UNITED STATES PATENT AND TRADEMARK OFFICE

| APPLICATION NO. | FILING DATE | FIRST NAMED INVENTOR | ATTORNEY DOCKET NO. | CONFIRMATION NO. |
|-----------------|-------------|----------------------|---------------------|------------------|
| 09/878,325 | 06/12/2001 | Tsuyoshi Kitahara | Q64826 | 2121 |

Office Action Summary

DETAILED ACTION

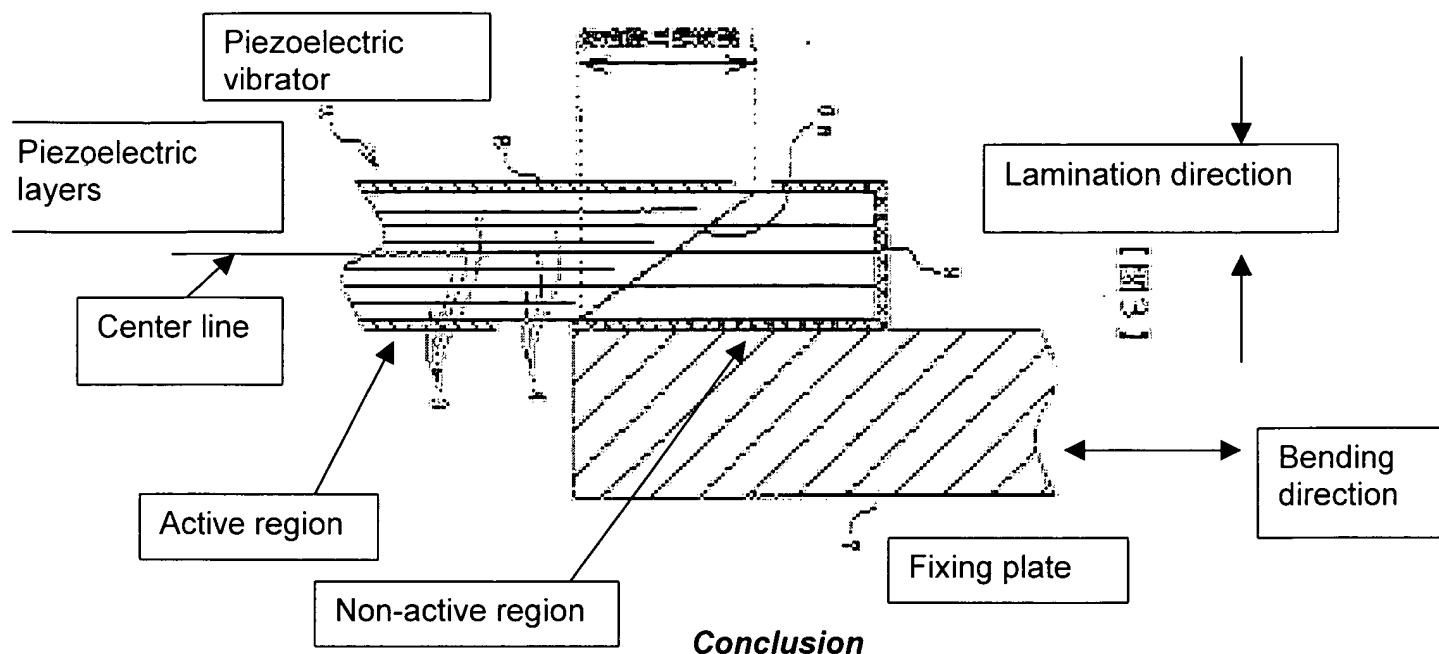
With respect to claims 1, 2, 5, 10 and 13, Kitahara discloses a piezoelectric vibrator comprising:

- Common internal electrode layers (Fig.3: element 4) and segment internal electrode layers arranged alternately (Fig.3: element 3)
- Piezoelectric layers, each interposed between adjacent pair of the common and segment internal electrode layers (Fig.3)

- External electrodes formed on an exterior of the piezoelectric vibrator and electrically connected respectively to the common internal electrode layers and the segment internal electrode layers (Fig.3: element 9)

- A fixing member to which a surface of the piezoelectric vibrator is fixed (Fig.3: element 7)
- The piezoelectric vibrator is displaceable in a direction perpendicular to a lamination direction in which the internal electrode layers and piezoelectric layer are laminated (Fig.3)

- A length of at least one of the internal electrode layer, located away from the surface fixed to the fixing member is shorter than other internal electrode layers (Fig.3).

- Piezoelectric layers are non-uniform in thickness (Fig.3)
- Internal electrode layers are non-uniformed in the thickness (Fig.3)

Since Kitahara discloses that the thickness of the piezoelectric layers are non-uniform then it's inherently having magnitude of electric fields applied to the

piezoelectric layers is non-uniform and electric fields applied to the piezoelectric layers have respective, different magnitude because of the resistivity is different between two layers with different thickness.

With respect to claim 4, Kitahara discloses a piezoelectric layer is located farther from the surface fixed to the fixing member in the lamination direction, magnitude of electric field applied to the piezoelectric layer is smaller (Fig.3), since thickness of the layer that far away from the fixing member is thinner than the layer that closed to the fixing member then the magnitude of electric field applied to the piezoelectric layer is smaller.

With respect to claim 6, Kitahara discloses at least one of the piezoelectric layer located away from the surface fixed to the fixing member is thicker than other piezoelectric layer (Fig.3).

With respect to claim 11, Kitahara discloses at least one of the internal electrode layers located away from a center line in the lamination direction is thicker than other internal electrodes (Fig.3)

With respect to claim 12, Kitahara discloses that an internal electrode layer is located farther from the surface fixed to the fixing member in the lamination direction, the internal electrode layer is thicker (Fig.3)

With respect to claim 17, Kitahara discloses the piezoelectric vibrator further includes a non-active portion that is not expanded or contracted even when the piezoelectric layers in an active region are driven and the fixing member is joined to a side surface of the non-active portion (Fig.3).
